Sub: Proposal for diversion of 86.479 ha forest land for construction of overhead conveyor belt from Barsuan Railway Siding to Kurmitar Iron Ore Mines of M/s OMC Ltd. (Proposal No.FP/OR /Others/ 44967/2020, dated 19.06.2020)

Ref: Memo No.7523/6F-(Mg.) dt 31.08.2020 by DFO, Bonai.

DIMENSION OF PILLAR & INSPECTION PATH

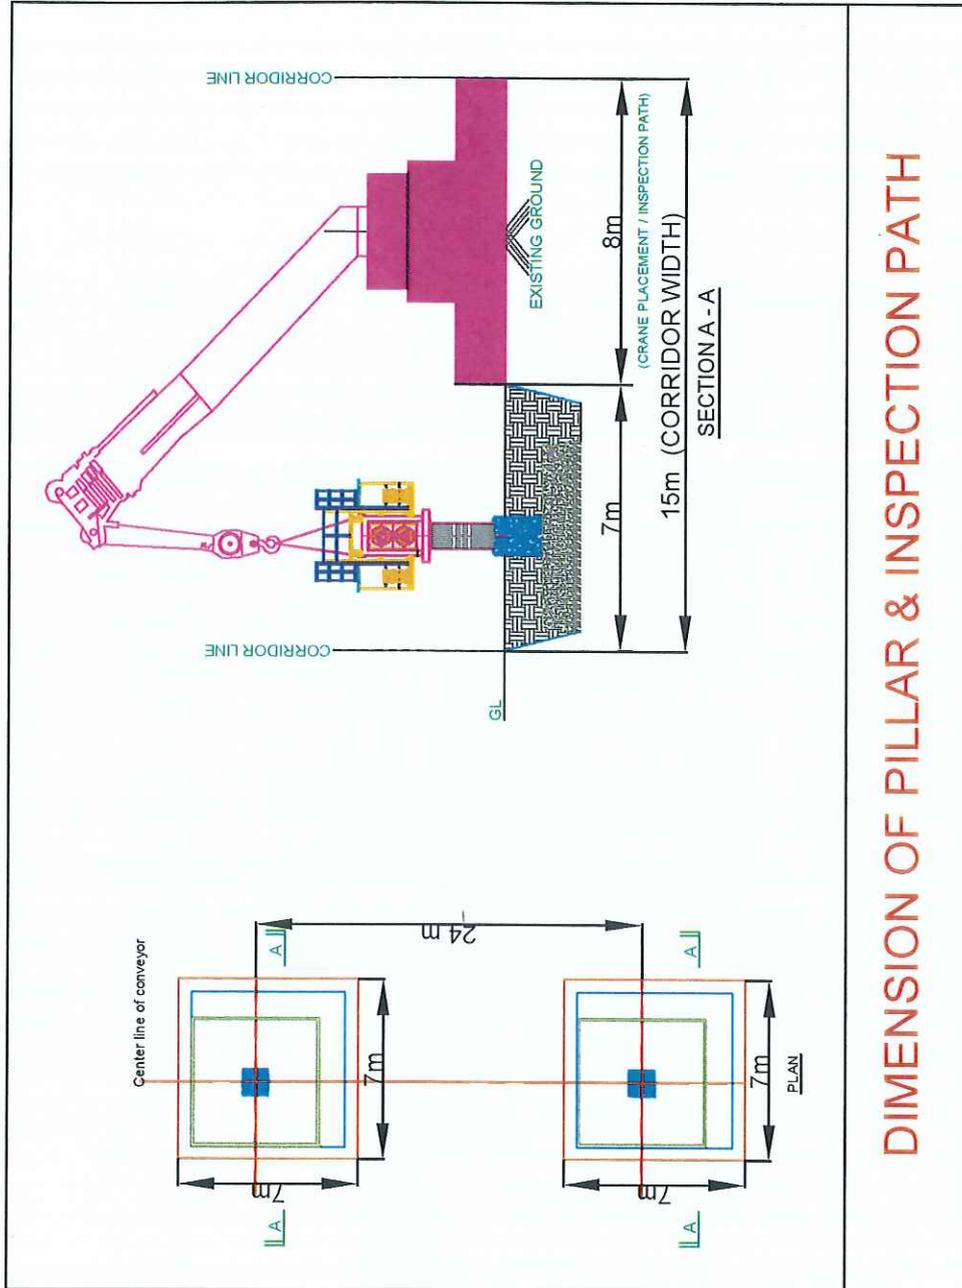
5.Observation No.5: Design of the pipe conveyor should be furnished.

In compliance, it is submitted that the detail design is being prepared by an UK based consultancy Agency to bring out the latest technology in the field of pipe conveyor transport mode. However, a note on the design of the pipe conveyor is given at **Annexure-II** for kind perusal. The sketch map showing the cross section & plan of a trestle pillar and the position of the Crane during construction phase is submitted herewith as **Annexure-III** for clarity.

PLAN SHOWING PROPOSED PIPE CONVEYOR WITH INSPECTION PATH & TRESTLE PILLARS.

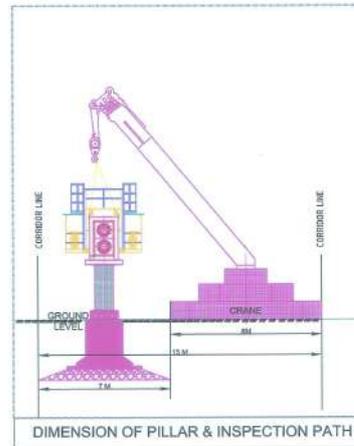
3. Observation No.3: The purpose wise utilization of forest area given at page 24/DP should also include No. of pillars to be constructed both in forest & non-forest area along the conveyor corridor to support the conveyor Pipe. It should also include the inspection Path/Road.

forest area given at Page No.24 of the DP (Revised Page No.22 & 23). Further the area proposed for inspection path along the corridor has been included in the same table placed at Page No.24 (Revised Page No.22 & 23). The trestle points and the inspection path have been shown in the **Plate No-VI** enclosed to the DP.
